## 23 Gloucester Crescent

### *Design and Access Statement*

Revised May 2021

This supporting statement forms part of a Listed Building Application seeking minor amendments to approval ref. 2020/4735/L (dated 27.01.202) and is accompanied by the following documents:

JOB Title: GLoucester Crescent  
RIDGE BOARD  
STRENGTHENING.

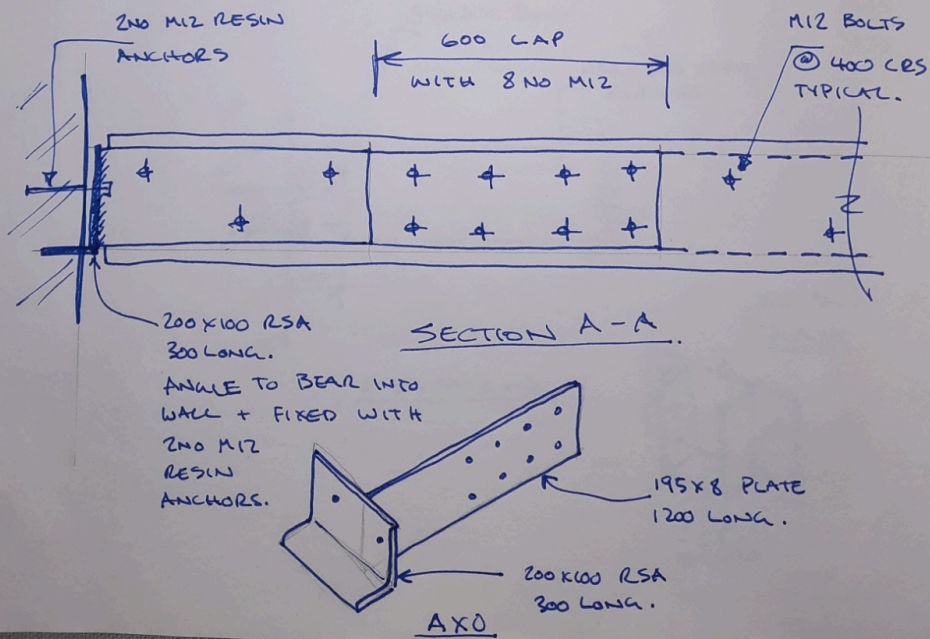
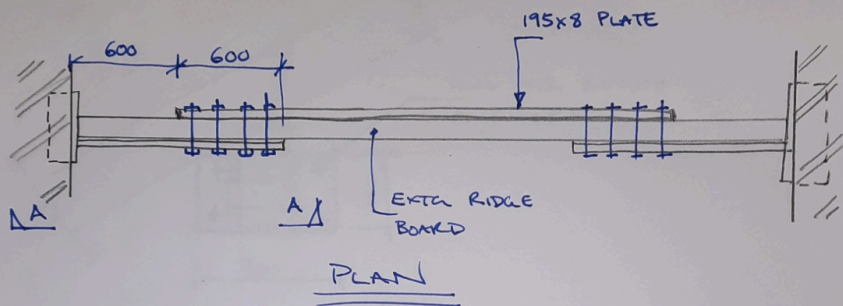
The Ridge beams are in poor condition and have inadequate bearing onto the masonry walls, therefore failing to alleviate the roof load from the damaged valley beam. The Morton Partnership requires the use of a steel 'splint' to one side of each ridge beam of to allow the ridges to be retained, re-supported and to in turn support the valley beam. The decayed bearing end of the valley beam as it meets the side wall requires intervention to restore bearing capacity if the beam is to be retained. The retention of historic fabric is a priority, so the Morton Partnership have detailed a steel support plate to replace the decayed timber and provide a secure bearing into the wall. No alterations to the wall will be required, however the removal of the decay will be needed, with two 195x10mm steel plates bolted together through original beam, welded to a stiffener plate and bearing plate set within the wall (refer to appendices).

- Steel plates to reinforce the bearing of the existing valley beam and two ridge beams in order to retain all existing roof fabric in situ, whilst achieving a secure long term structural solution.
- 25mm deeper rafters than the existing are required to achieve the roofspan, these new rafters will be interspersed between the originals and used where the terrace used to be, insulated and lime plastered as per the existing approval.
- Code 5 lead ridges replace clay ridge tiles reinstating the original detail.

Morton Partnership details for purlin connections to masonry walls minimizing intervention to the brickwork.

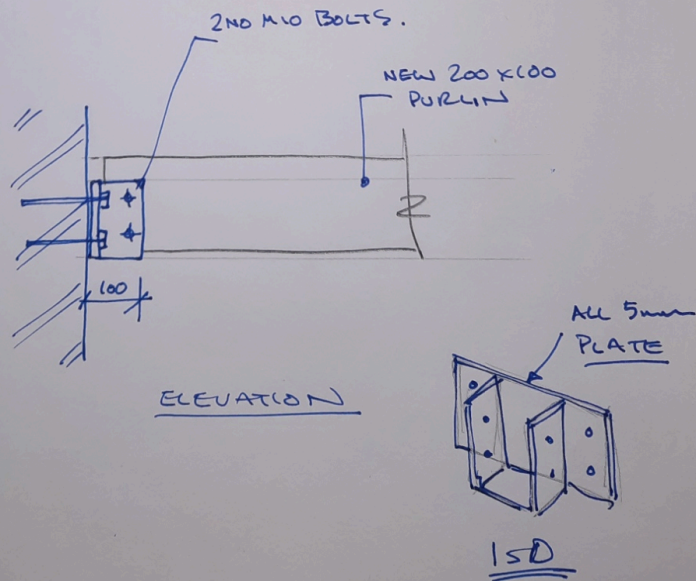
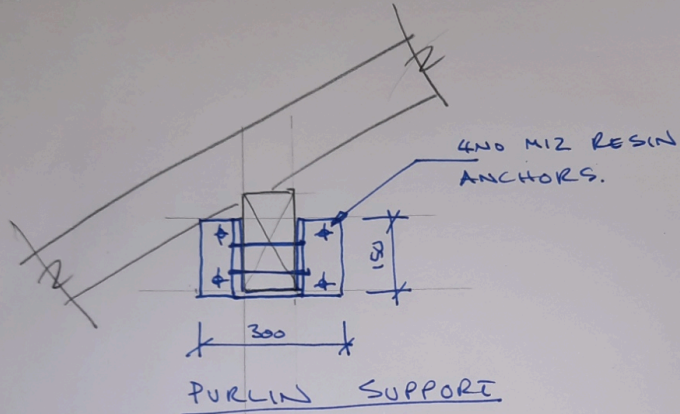
The original rafters are 100mm (4") in depth and are inadequate to sustain the slate roofing load given age and condition. The Morton Partnership Engineer requires 125mm (5") deep rafters for safe loading, which we proposed to use in between the original rafters, therefore preserving them in-situ. The reinstated purlins mean that the weakened valley beam can remain in situ without reinforcement. The rooflight position as been adjusted to accommodate the reinstated purlin.

Following opening up associated with the approved removal of the roof terrace and reinstatement of the timber roof, engineer calculated steel strengthening plates described in the appendices i - iv are proposed, sitting within the existing roof structure they remain unseen after the approved insulation and finishes are applied. The existing timber rafters are retained but supplemented with new 125mm timbers placed between the existing rafters, the purlins lost though the terrace installation are reinstated.
